Accessible Housing: Drafting of proposed NCC changes

2020

This document outlines proposed changes to the text of the National Construction Code (NCC), which may be implemented if governments decide to proceed with regulation for a minimum standard for accessibility in new housing.

Diagram 3b – Location of noggings (shower—side wall)

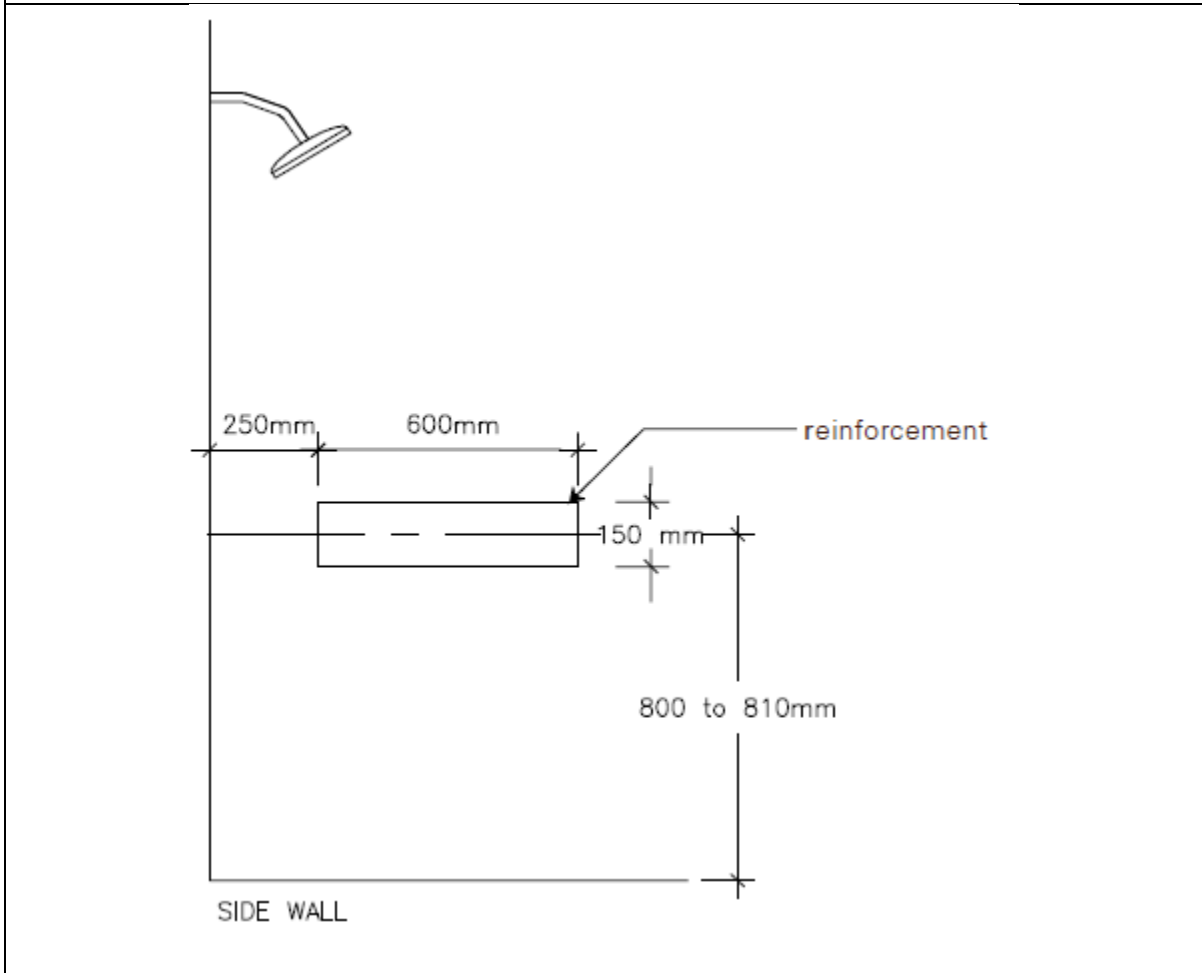
- (A) noggings are installed in the locations shown in **Figure F2.11 — diagrams 3a, 3b or 3c**; or
- (B) plywood sheeting is installed in the locations shown in **Figure F2.11 — diagram 4**; and

After new clause F2.11 / 3.8.3.5, insert new Figure F2.11 / 3.8.3.5 as follows:

Diagram 3c – Location of noggings (shower—plan view)

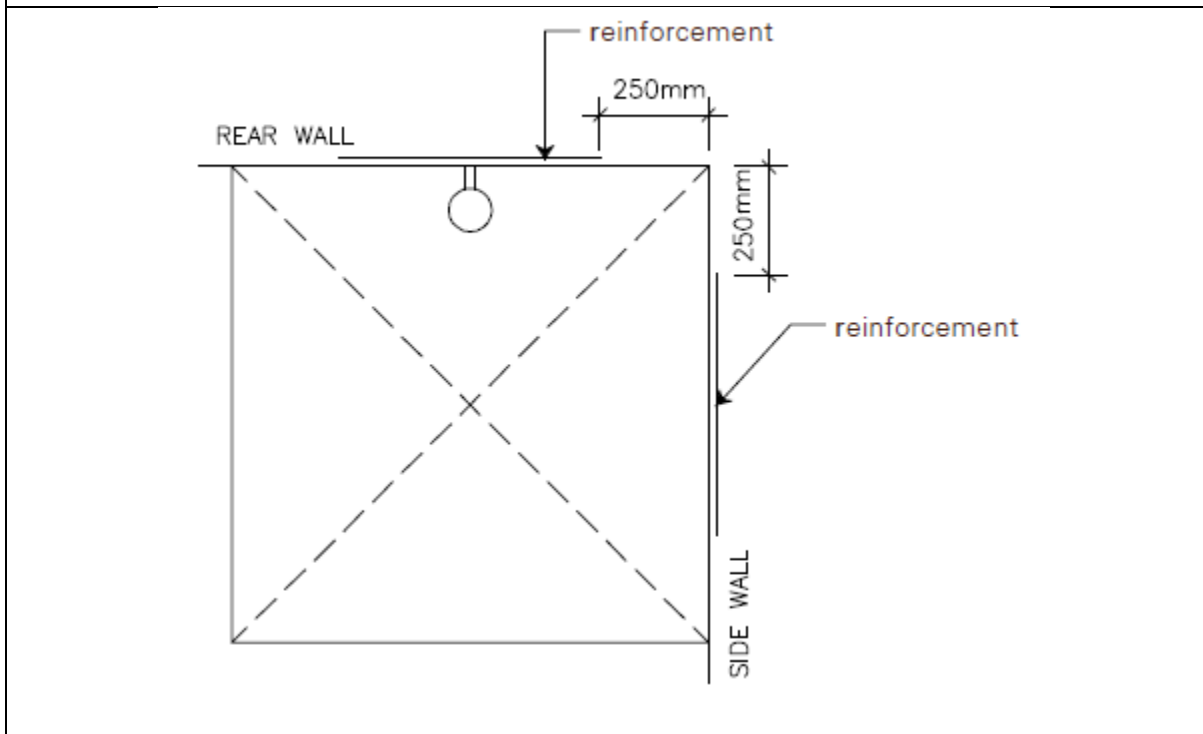
After new clause F2.11 / 3.8.3.5, insert new Figure F2.11 / 3.8.3.5 as follows:

Diagram 4 – Location of sheet reinforcing (shower)

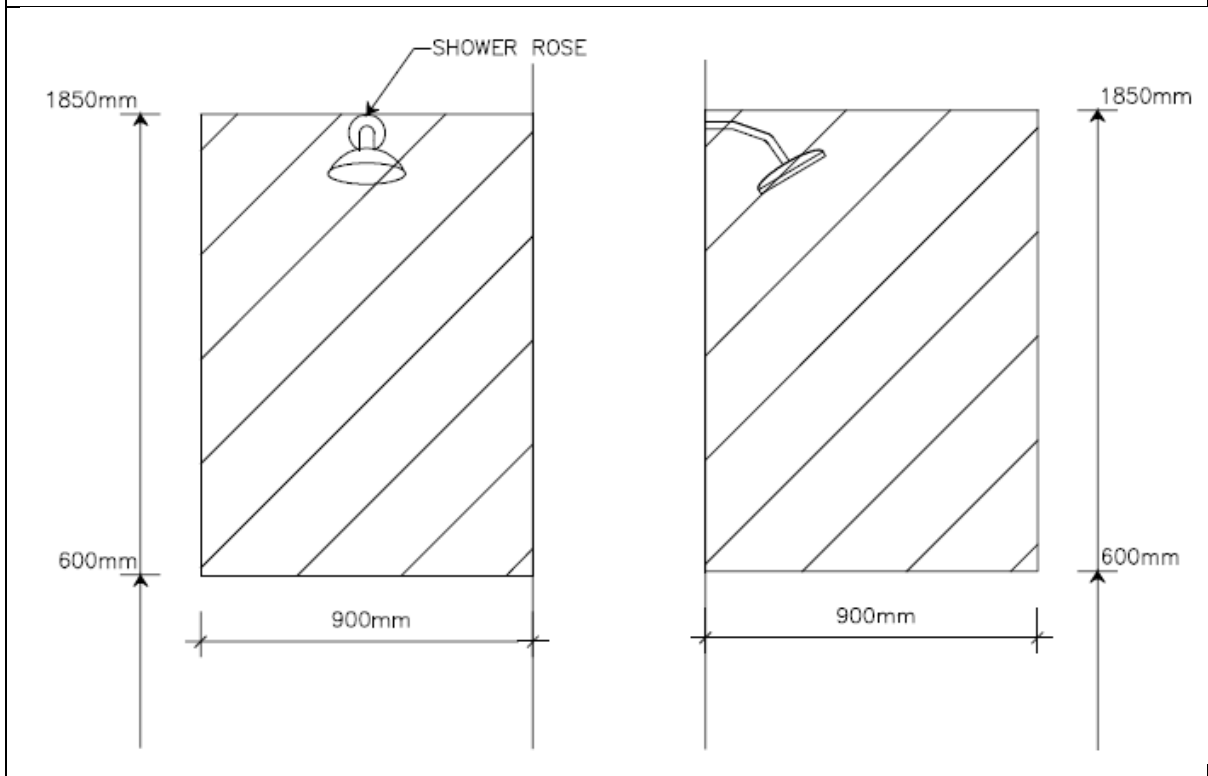
After new clause F2.11 / 3.8.3.5, insert new Figure F2.11 / 3.8.3.5 as follows:

Diagram 5a – Location of noggings (bath—long edge)

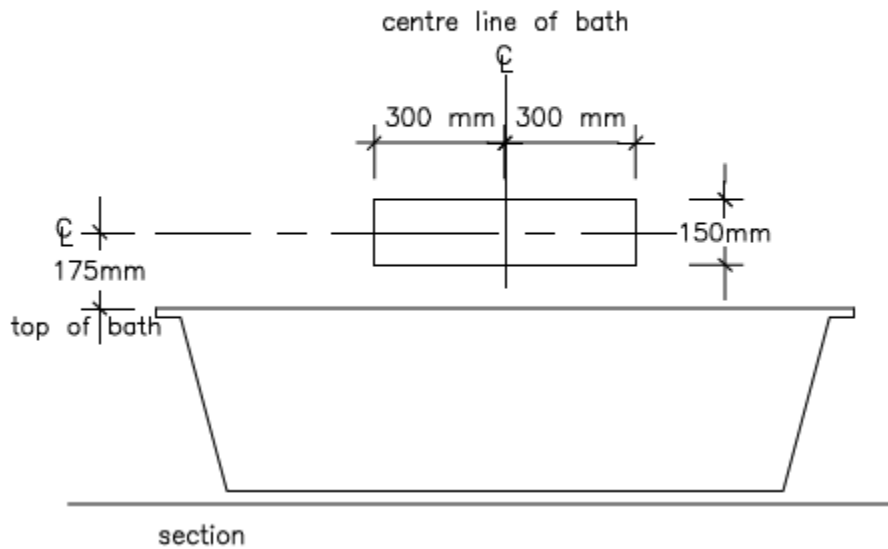
- (iii) a bath that is in the same room as a shower *required* to comply with **F2.10**, so that—
 - (A) noggings are installed in the locations shown in **Figure F2.11 — diagrams 5a and 5b**; or

After new clause F2.11 / 3.8.3.5, insert new Figure F2.11 / 3.8.3.5 as follows:

Diagram 5b – Location of noggings (bath—short edge)

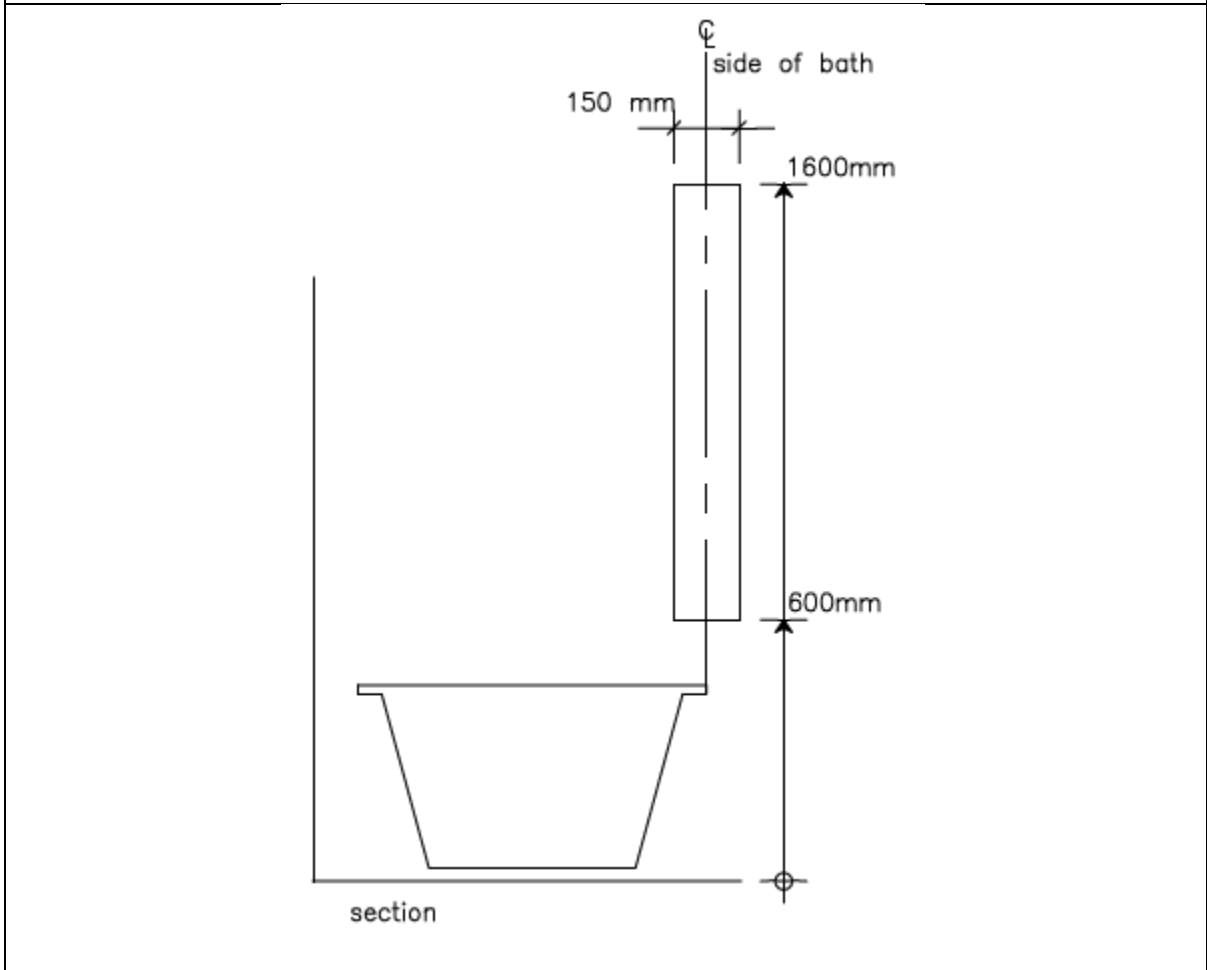
After new clause F2.11 / 3.8.3.5, insert new Figure F2.11 / 3.8.3.5 as follows:

Diagram 6a – Location of sheet reinforcing (bath—long and short edges)

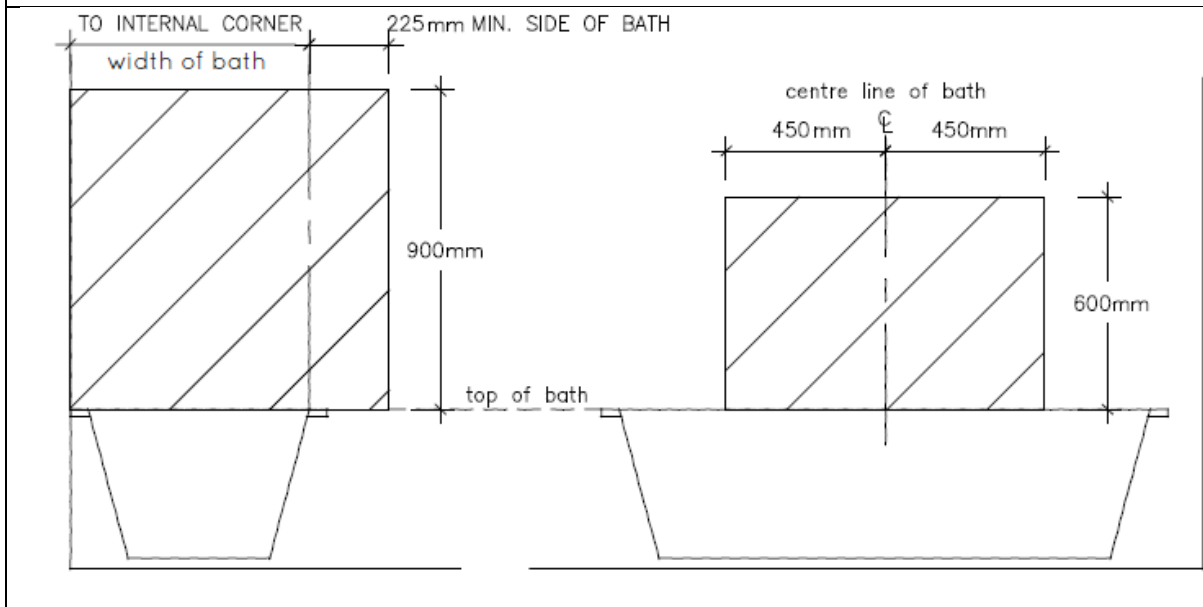
- (B) plywood sheeting is installed in the locations shown in **Figure F2.11 — diagrams 6a and 6b**.
- (b) Where the dimensions of a closet pan subject to **(a)(i)** are unknown, it may be assumed that the front edge of the pan will extend not more than 800 mm (+/- 10 mm) from the wall behind the pan.

After new clause F2.11 / 3.8.3.5, insert new Figure F2.11 / 3.8.3.5 as follows:

Diagram bb – Location of sheet reinforcing (bath—isometric view)

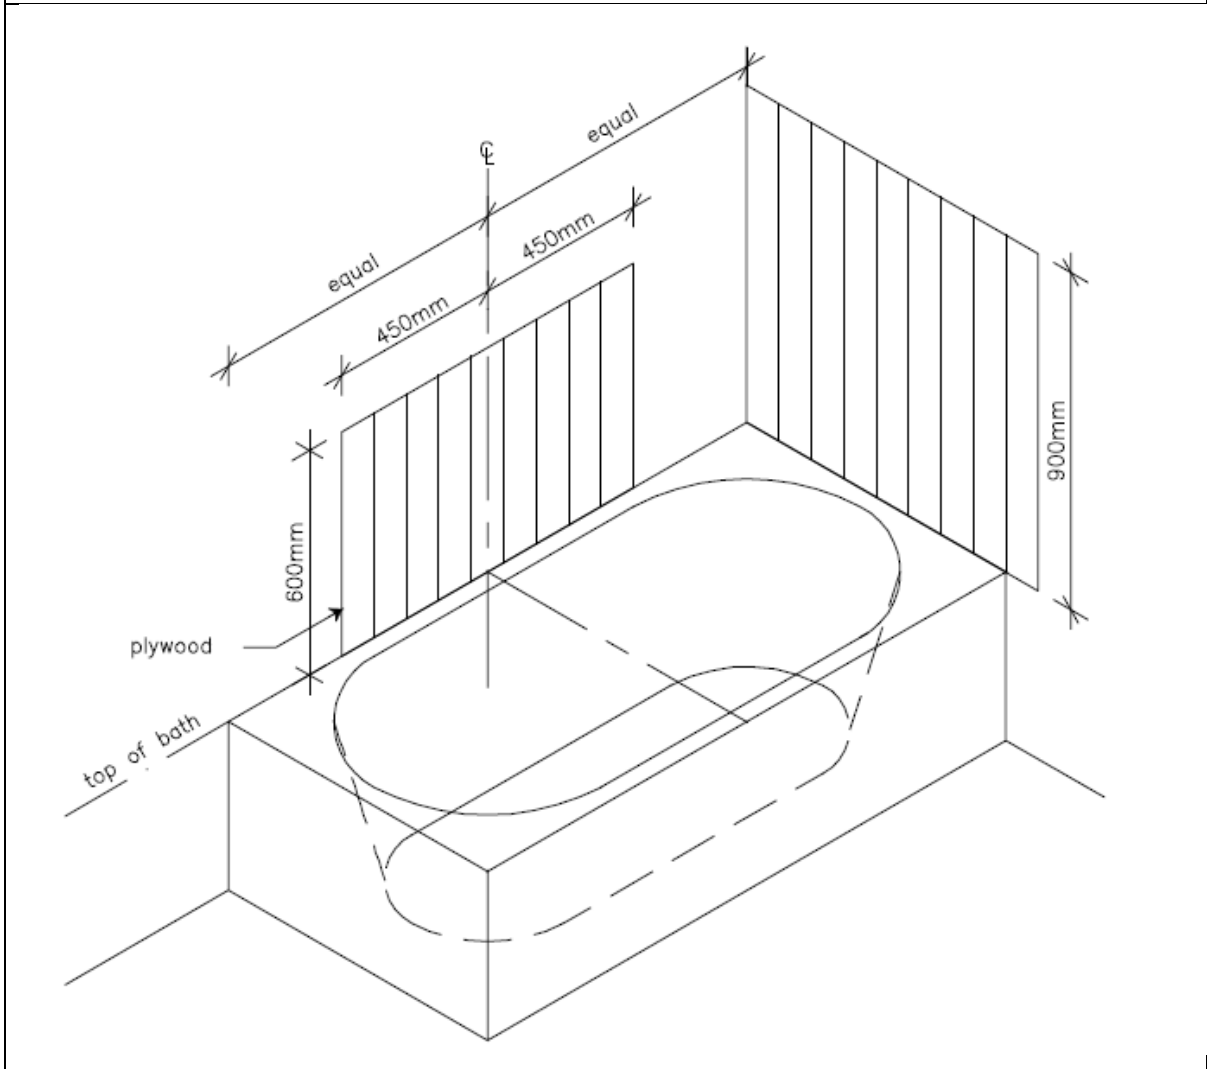
After new clause F2.11 / 3.8.3.5, insert new Figure F2.11 / 3.8.3.5 as follows:
